FLYING HORSE NORTH FILING NO. 2

FLYING HORSE NORTH
FILING NO. 2
JOB NO. 1306.00
JANUARY 3, 2022
SHEET 1 OF 2

PCCD FILE NO.: SF-228

FLYING HORSE NORTH
FILING NO. 2
JOB NO. 1306.00
JANUARY 3, 2022
SHEET 2 OF 2

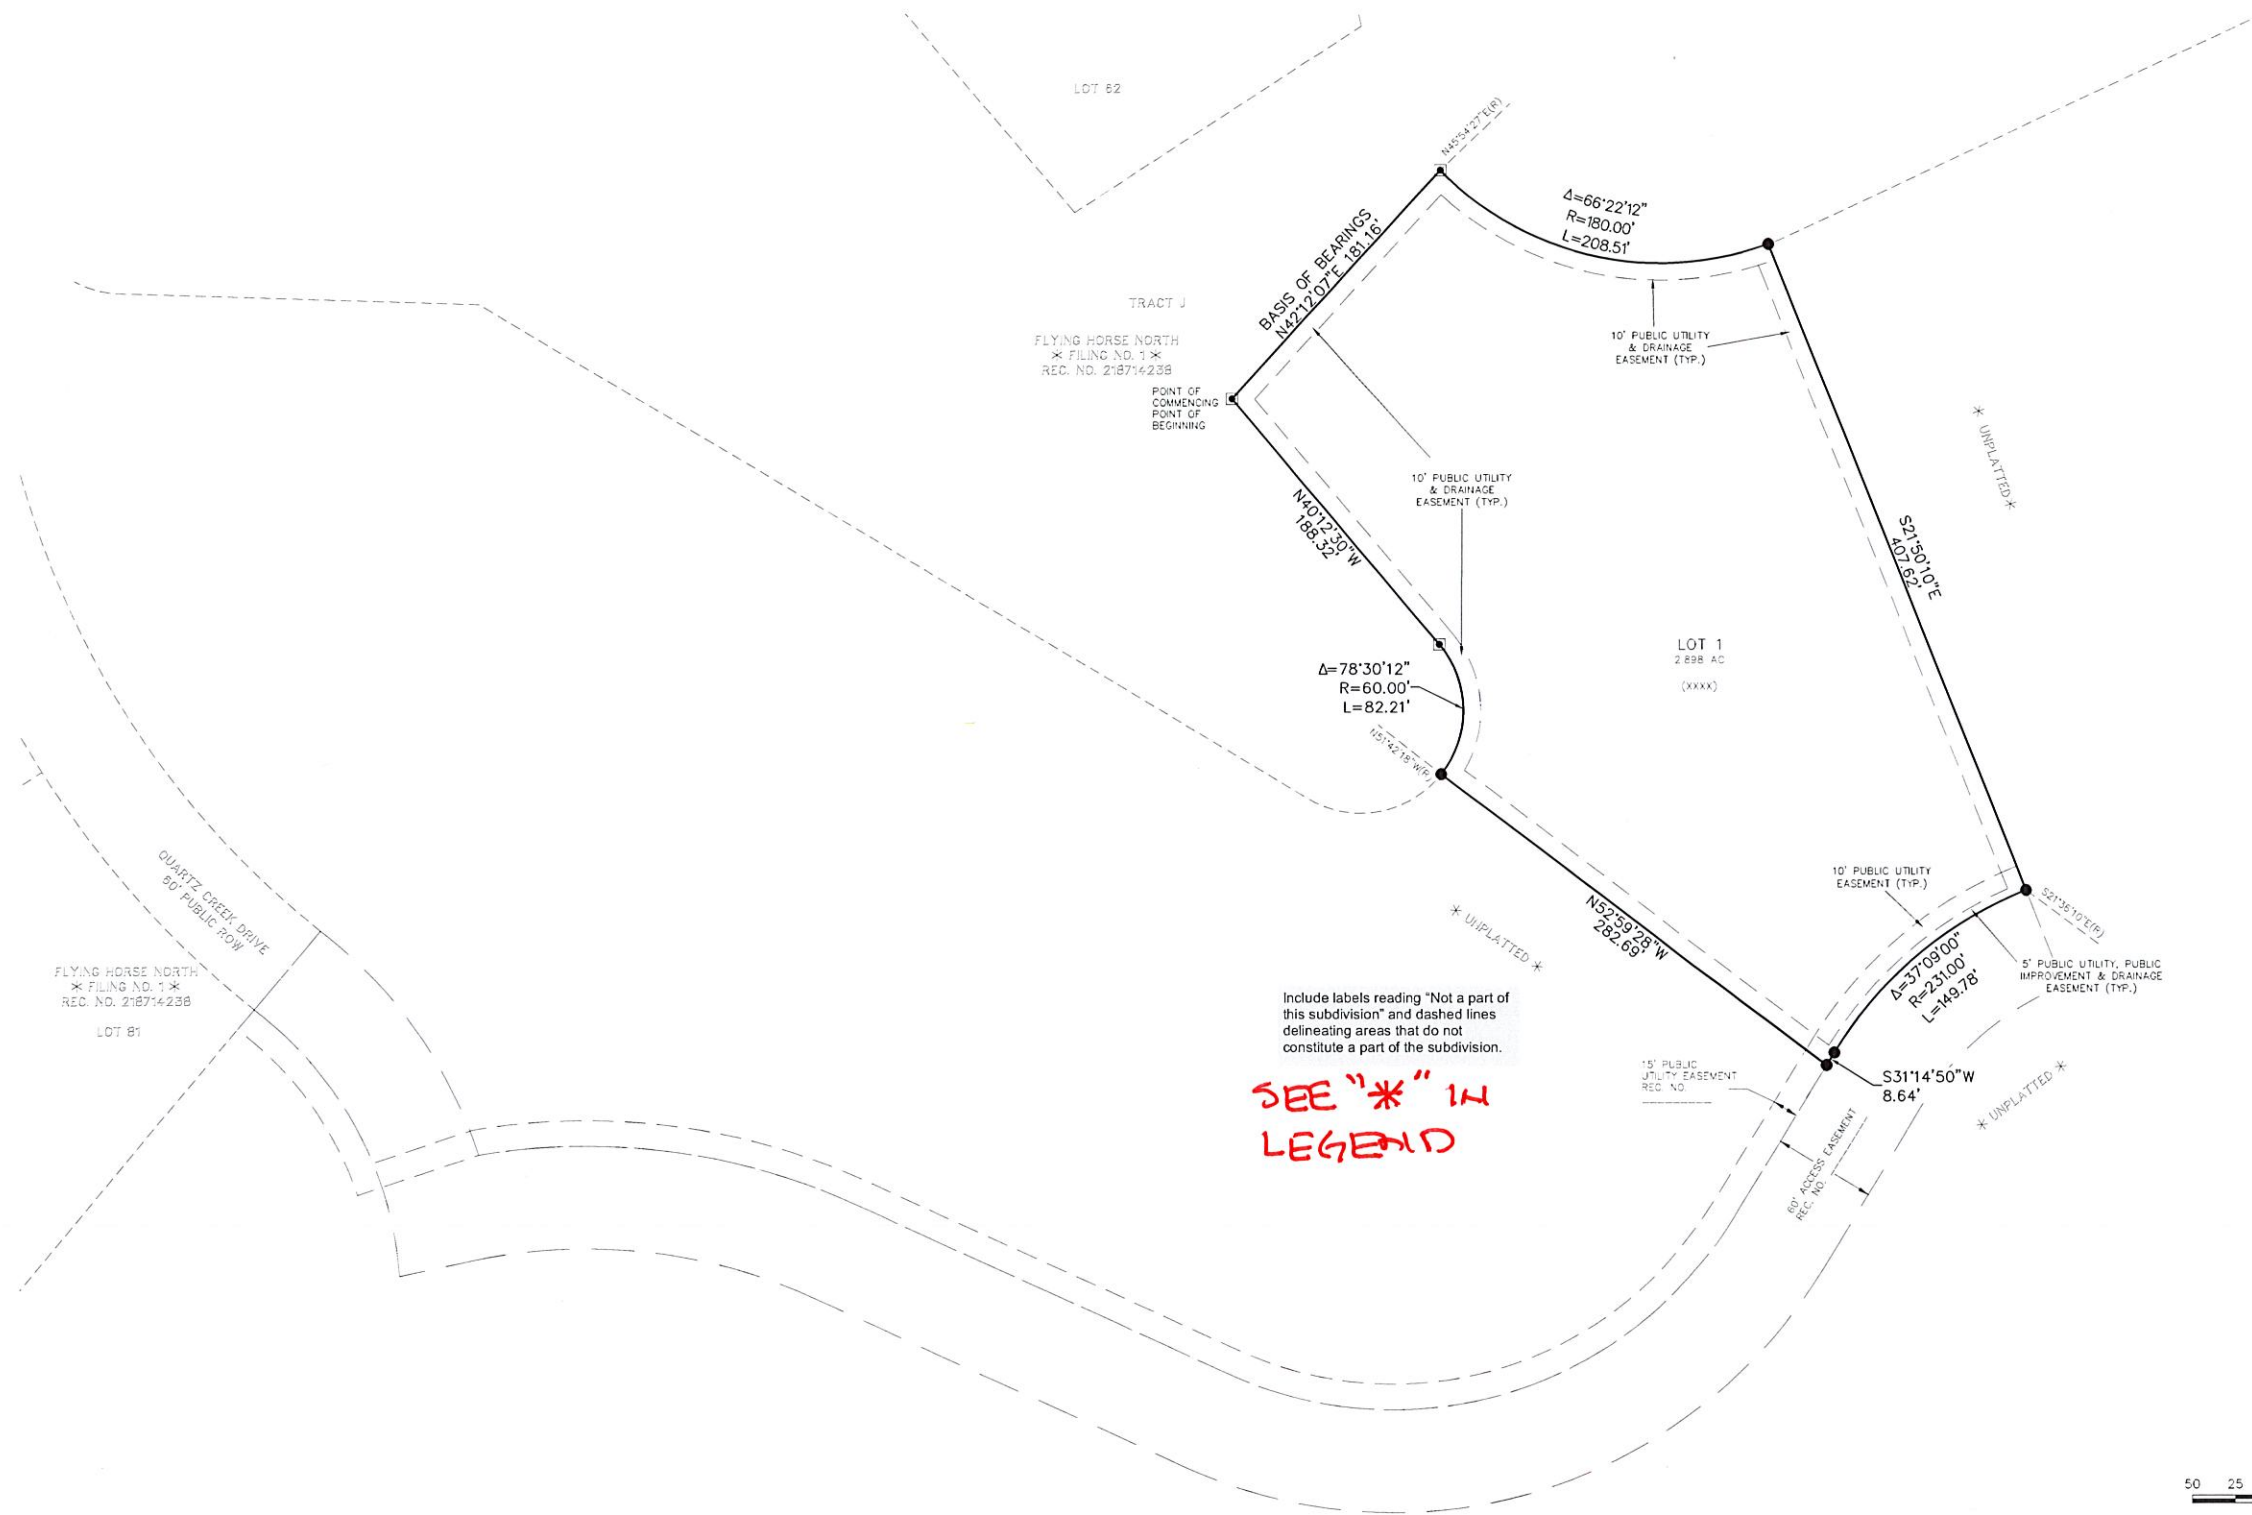
Include labels reading "Not a part of this subdivision" and dashed lines delineating areas that do not constitute a part of the subdivision.

SEE "*" IN LEGEND
